A303 Amesbury to Berwick Down

Deadline 2
8.10.5 Cultural heritage (CH.1)

Cultural heritage (CH.1)

Regulation Number:	Regulation 5(2)(q)
Planning Inspectorate Scheme Reference	TR010025
Application Document Reference	8.10.5
Author:	A303 Amesbury to Berwick Down Project Team, Highways England

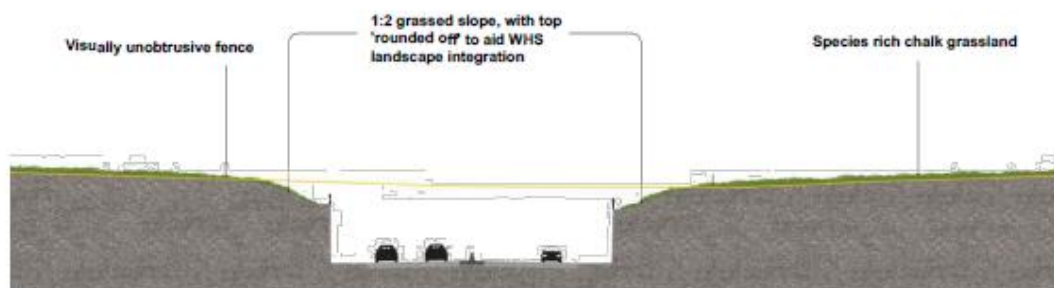
- i. Please provide illustrative evidence (visual modelling) of its relationship to the winter solstice alignment, together with evidence to show that headlights of cars in the cutting leading to the tunnel would not interfere with viewings of the sunset from the stones.
- ii. Also, illustrate how the Option would impact on visual relationships with Winterbourne Stoke Crossroads barrows, Normanton Down Barrows, the Diamond Group, and wider connections; and its relationship to the RSPB reserve (See also ES Chapter 6, Para 6.8.5(ii)).

2. Figure G of the Environmental masterplan [APP-059] (extract below) indicates how vehicles would be situated in a retained cutting beneath existing ground levels, such that headlights of cars would not be visible from Stonehenge.

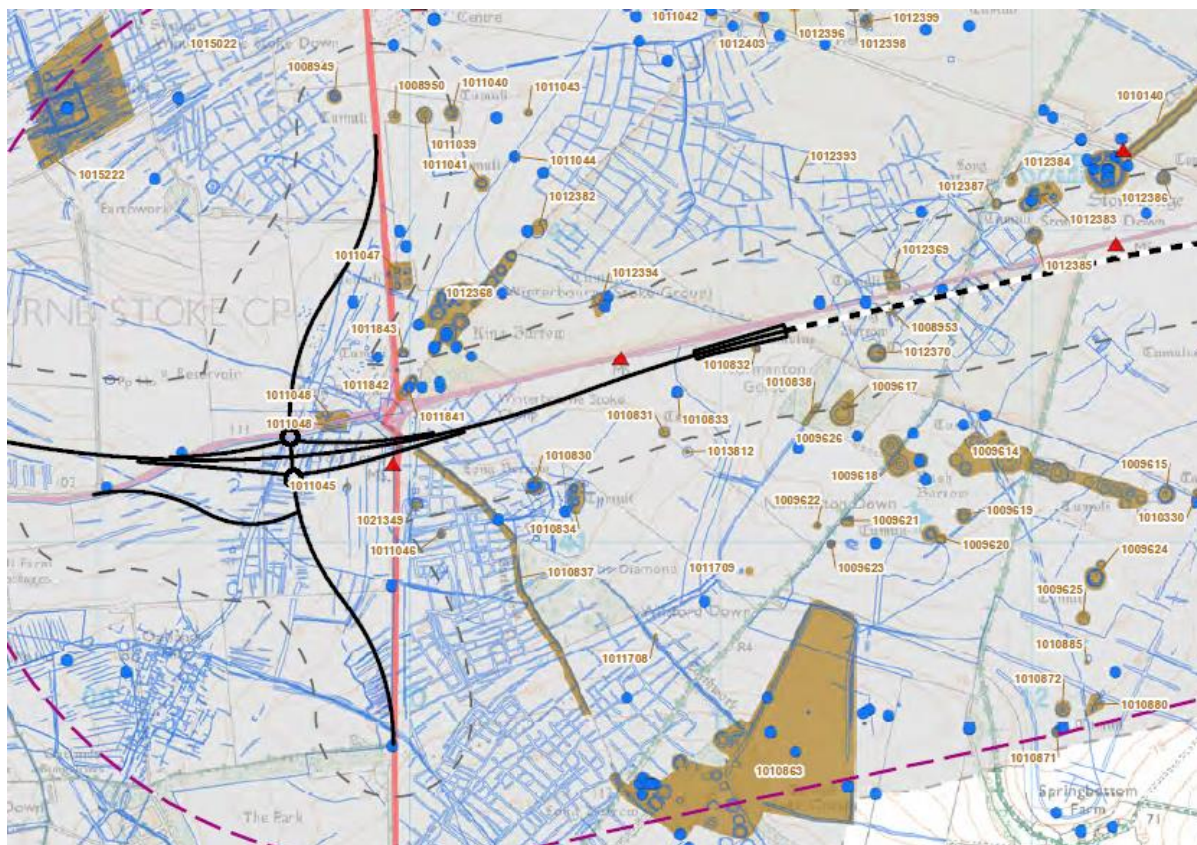
- ii. **Also, illustrate how the Option would impact on visual relationships with Winterbourne Stoke Crossroads barrows, Normanton Down Barrows, the Diamond Group, and wider connections; and its relationship to the RSPB reserve (See also ES Chapter 6, Para 6.8.5(ii)).**

5. Figure 7 (below) from the Scheme Assessment Report (Volume 7 Appendix E Historic Environment) [REP1-029] provides illustrative evidence of how Route Option 1Nd would impact on visual relationships with the AG12 Winterbourne Stoke Crossroads Barrows (to the northeast of the existing Longbarrow roundabout), AG19 the Normanton Down Barrows (in the vicinity of Normanton Gorse), and AG13 the Diamond Group (to the southeast of the existing Longbarrow roundabout), and wider connections. Further information regarding the impacts of Option 1Nd as reported at Preferred Route Announcement and explanation of the diagram below can be found in Deadline 1 Submission - Scheme Assessment Report - Volume 7 - Appendix E [REP1-029, Section 5.2] and also in Highways England's response to AL.1.16

Drawing Title
**ZONE 3 MAIN LINE TUNNELS
LONGITUDINAL SECTION
UPPER ALIGNMENT LAND
REQUIREMENTS -
FOR DISCUSSION**

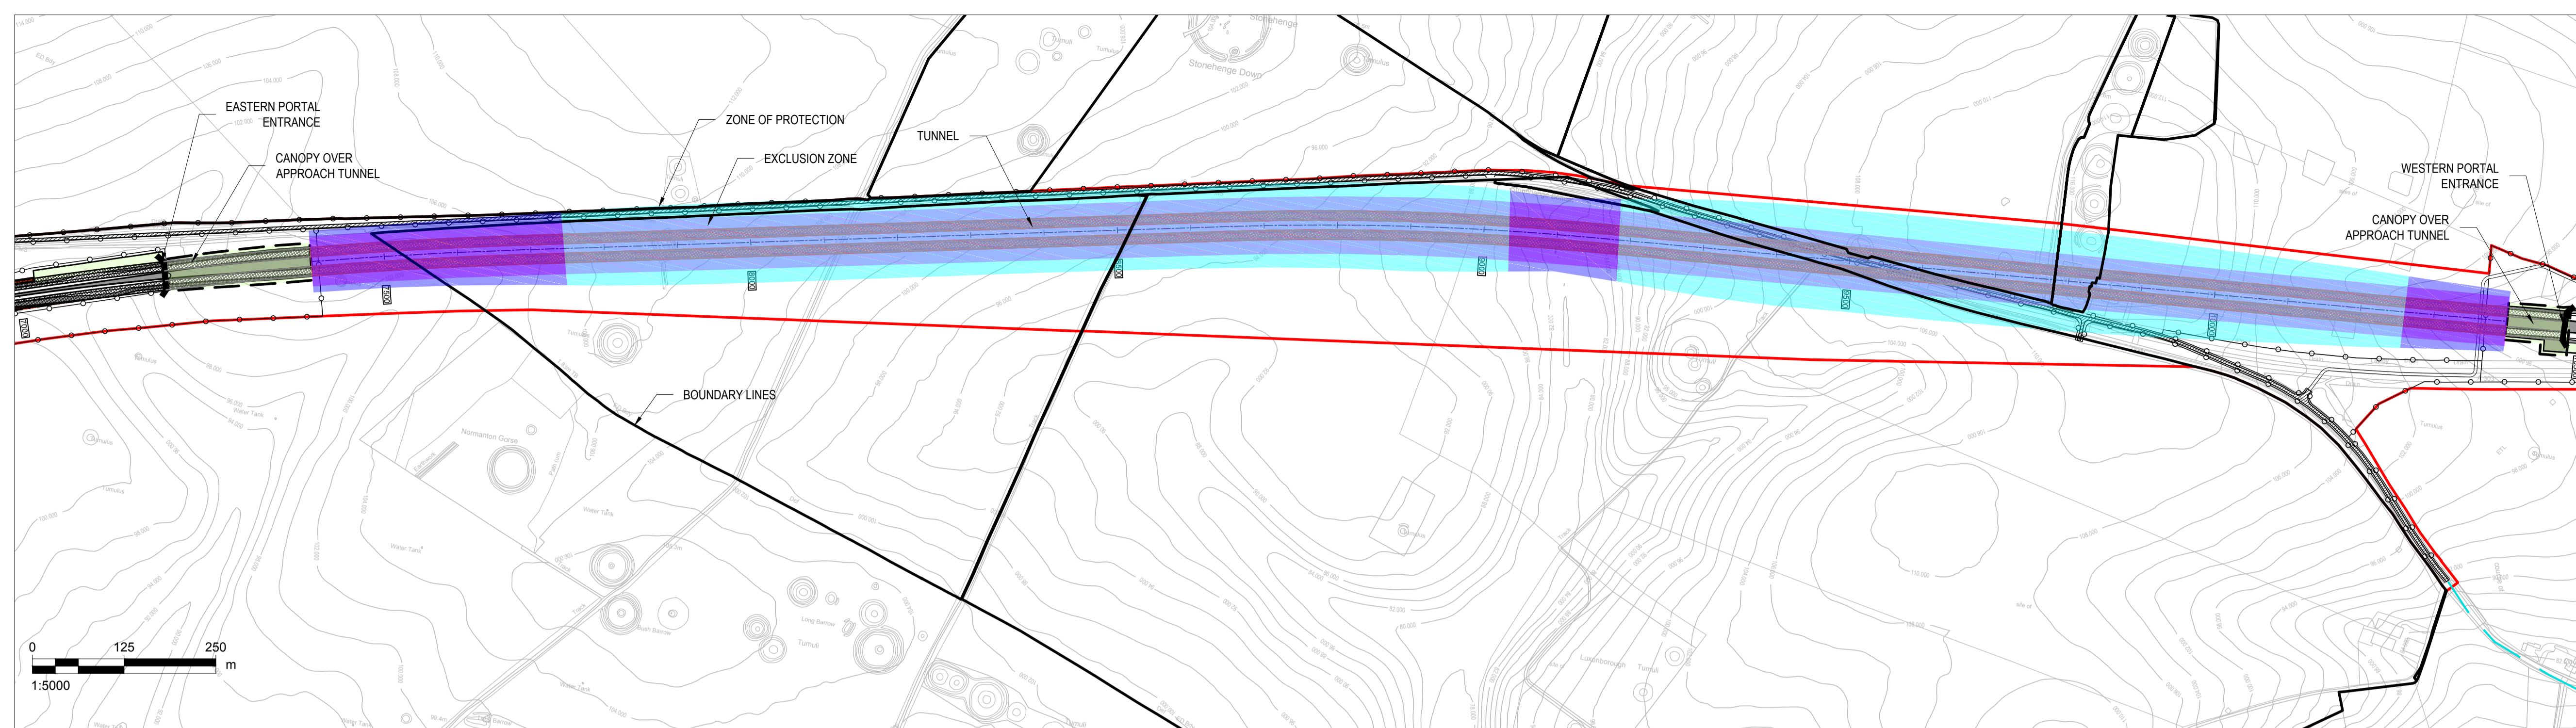
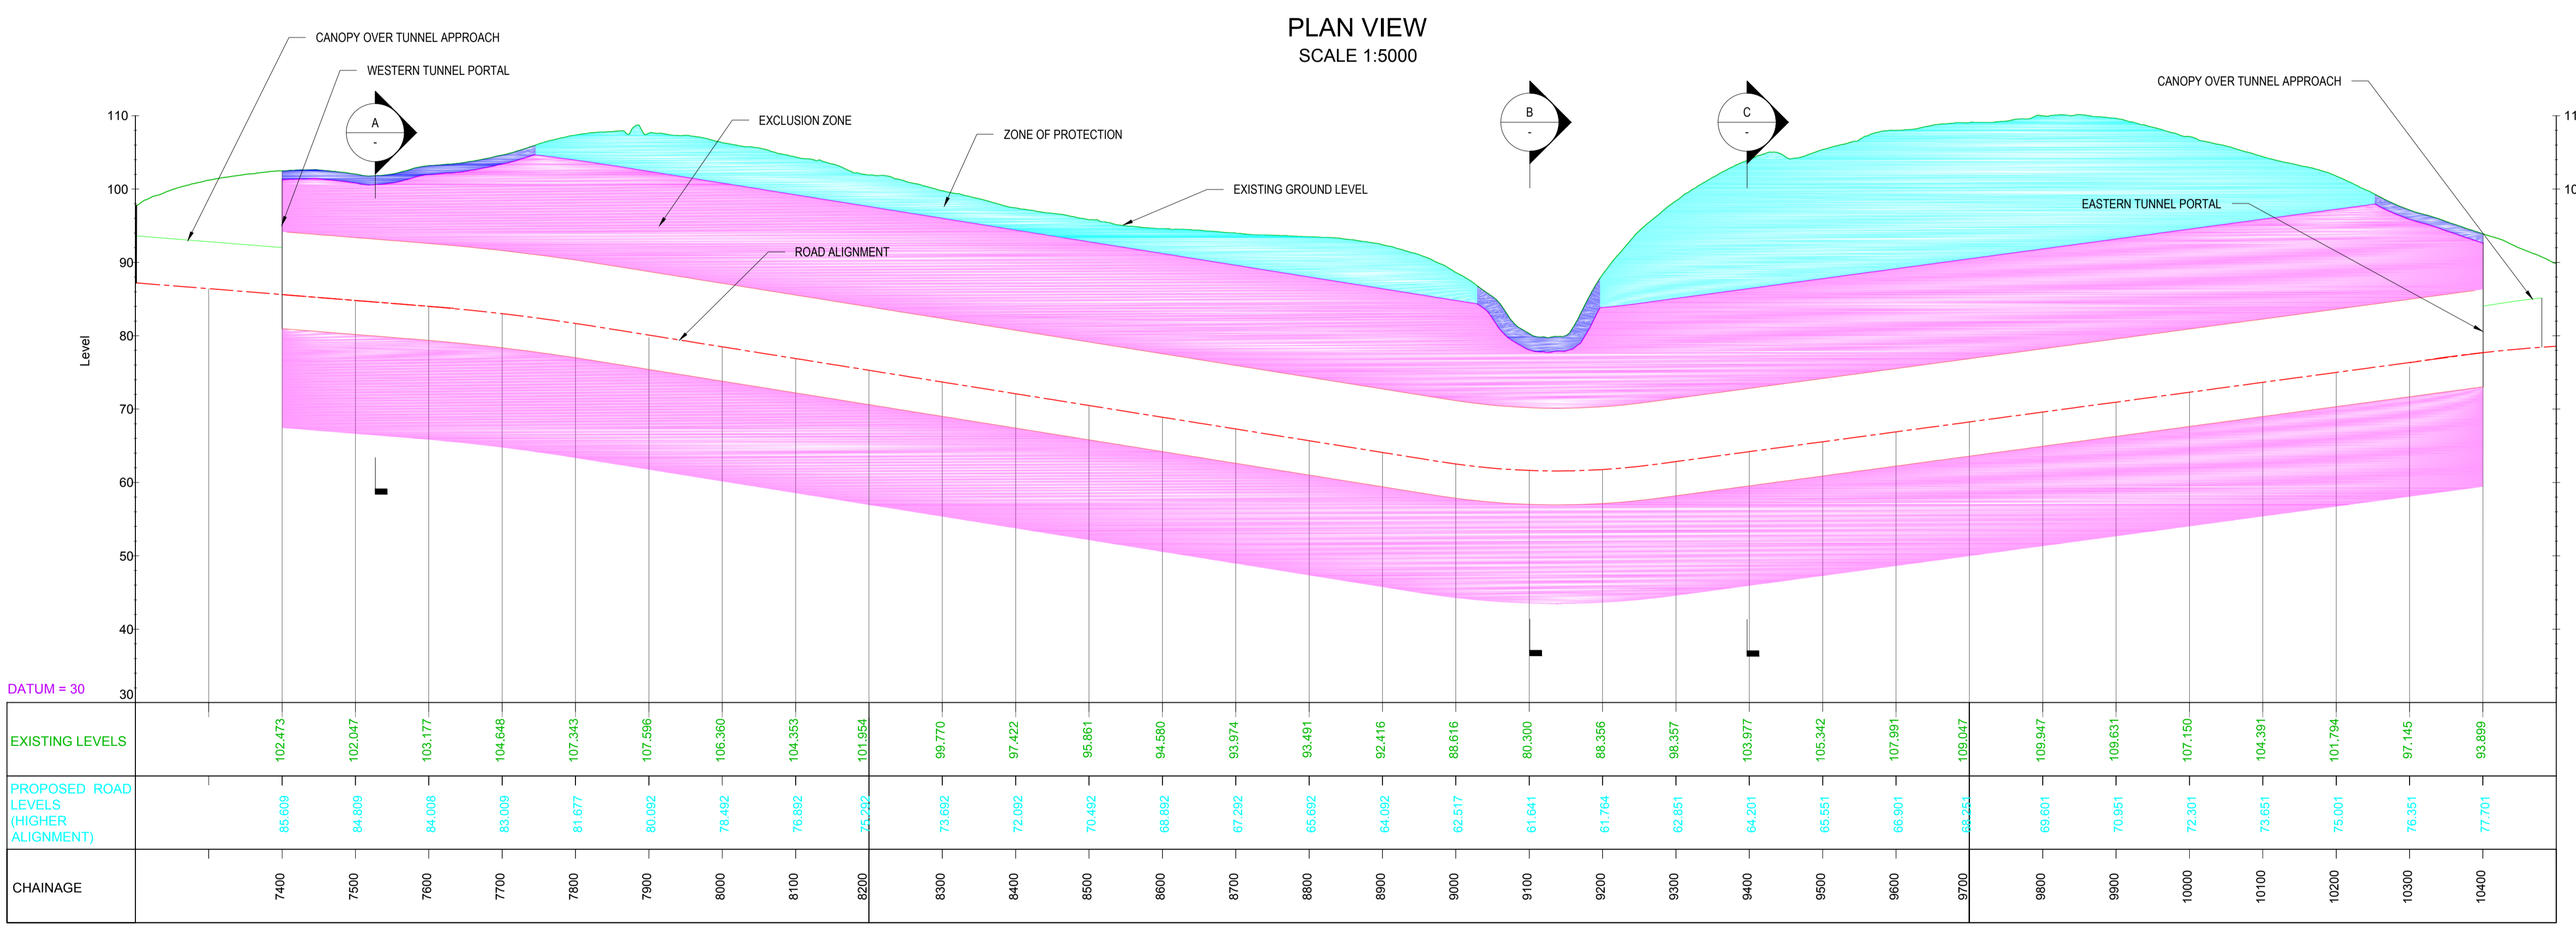
- i. **What restrictions on future archaeological research, above the tunnel route and elsewhere, are envisaged?**
2. In response to (i), as set out in sections 5.3.6, 5.3.7 and Figure 1 of the Statement of Reasons [APP-023], Highways England seeks powers to acquire compulsorily subsoil for the bored tunnel, to the extent necessary to construct, operate and maintain the tunnel. Highways England therefore requires the subsoil within which the tunnel would lie, together with a 'layer' of additional subsoil around the tunnel itself; the additional layer, which would form a protective barrier around the tunnel, is referred to in the Statement of Reasons (see in particular Figure 1) as the 'exclusion zone'.

- PERMANENT ACQUISITION
- RESTRICTION DARK BLUE AREA: 0.6M DEPTH
- RESTRICTION LIGHT BLUE AREA: 1.2M DEPTH

Drawing Title
**ENVIRONMENT
MASTERPLAN
INDICATIVE CROSS
SECTIONS - FIGURE 2.5 T**

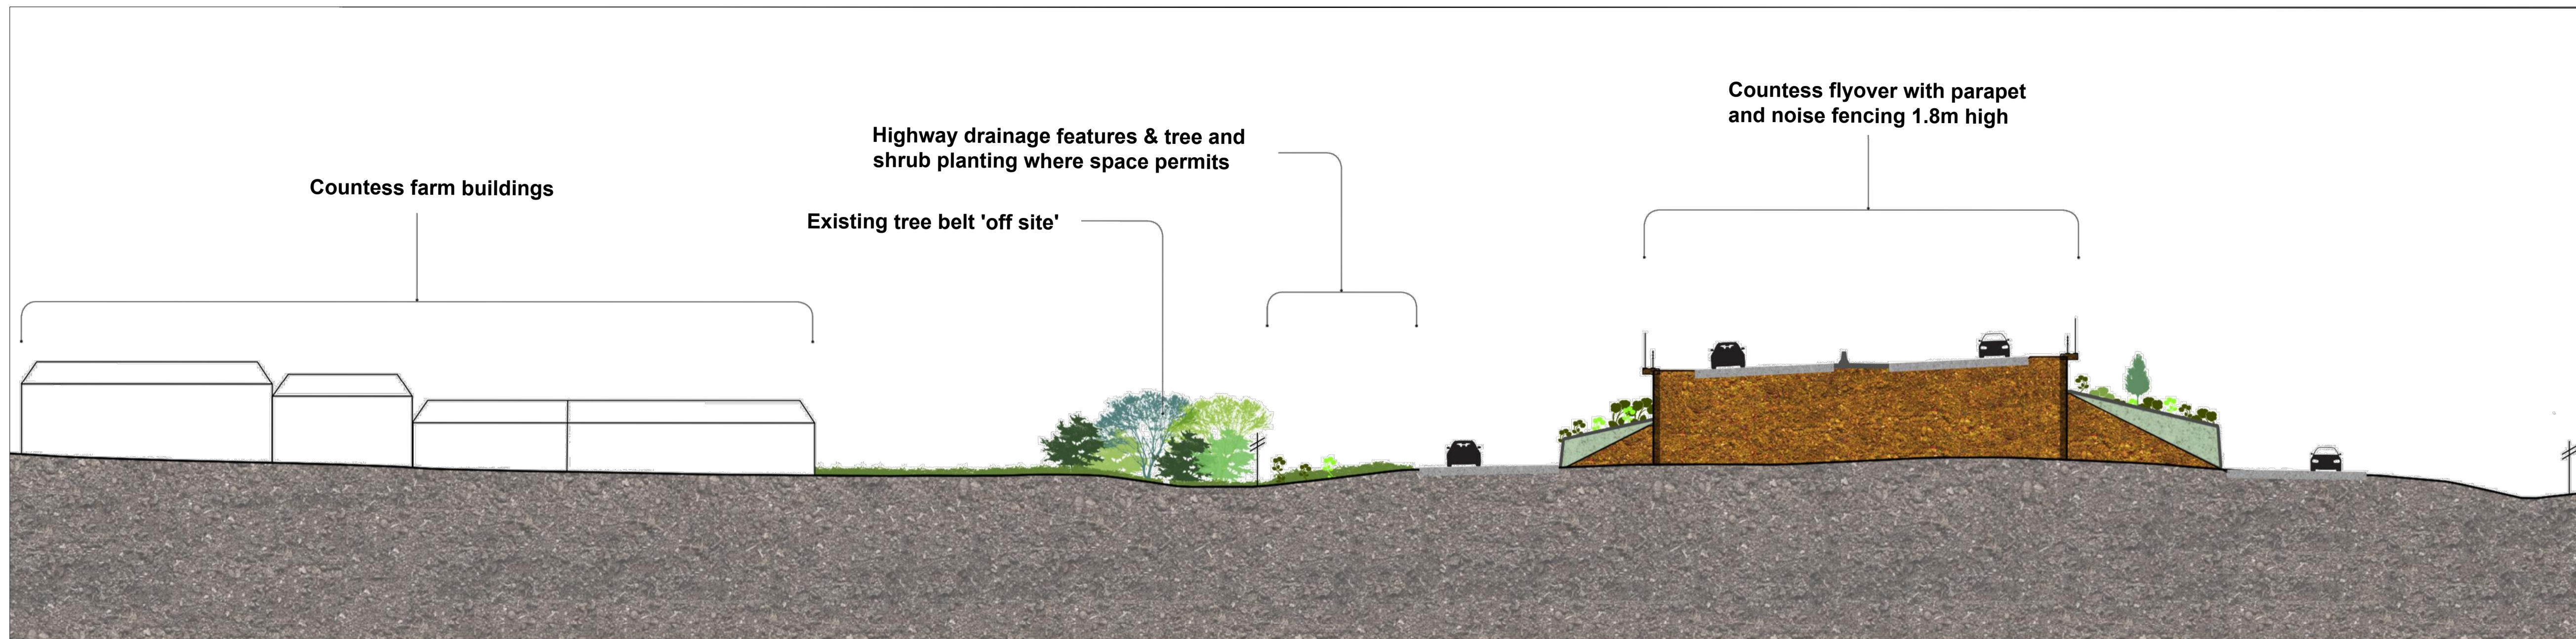
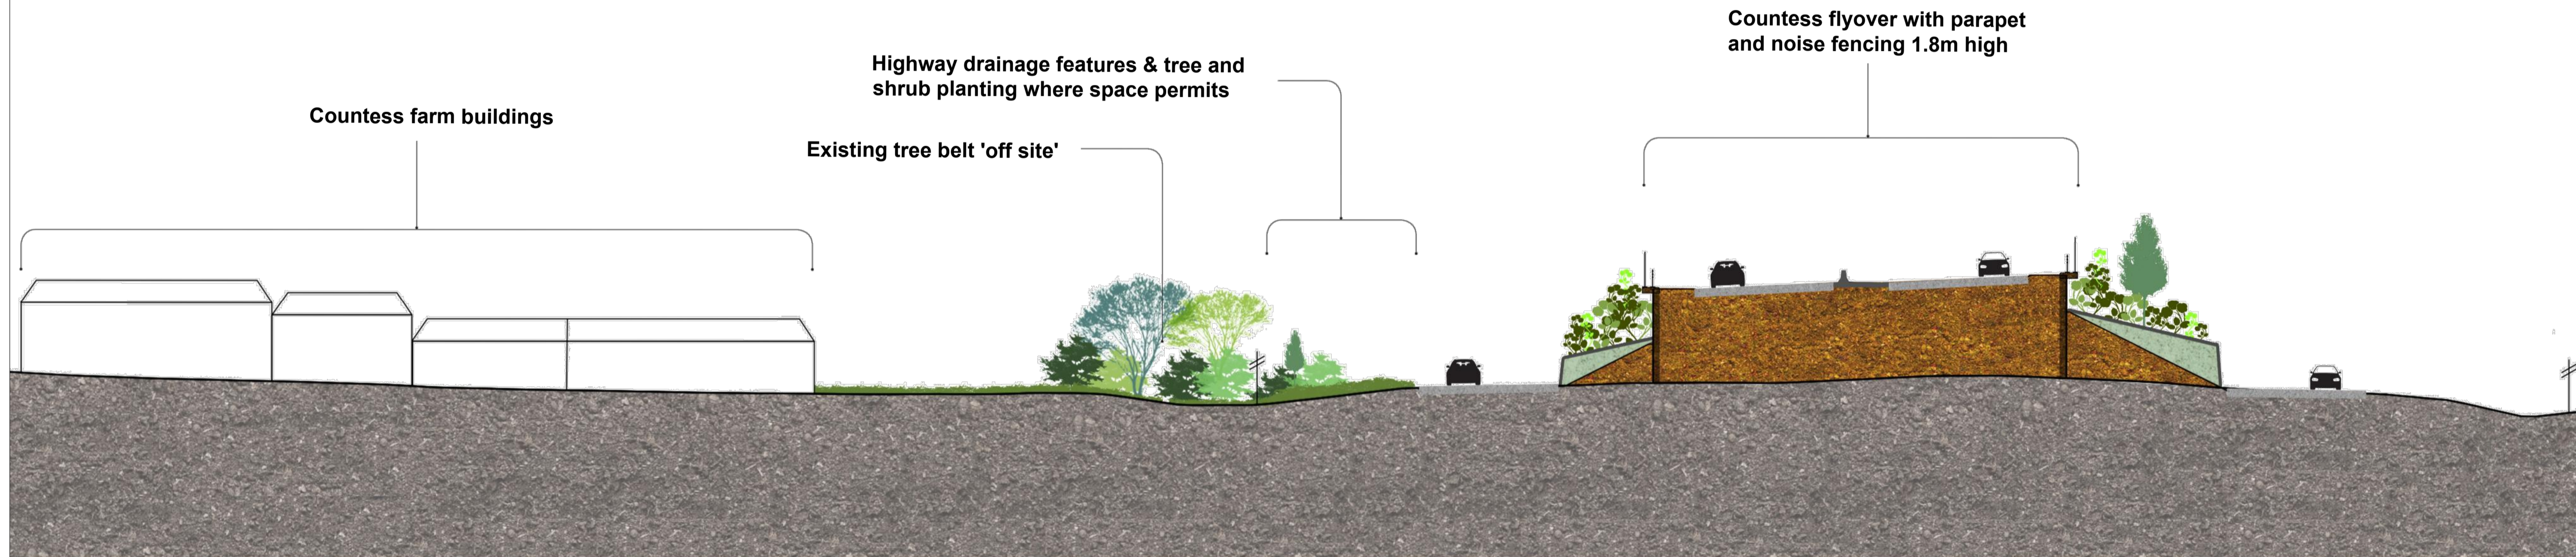
Question CH.1.47

2. The planting proposals would screen the lower parts of the Countess flyover retaining walls and slip-roads and soften views of the upper parts of the flyover at year 15 of operation, via the planting between the slip roads and flyover as indicatively set out on the Environmental Masterplan (Environmental Statement Figure 2.5 A-S [APP-059]).
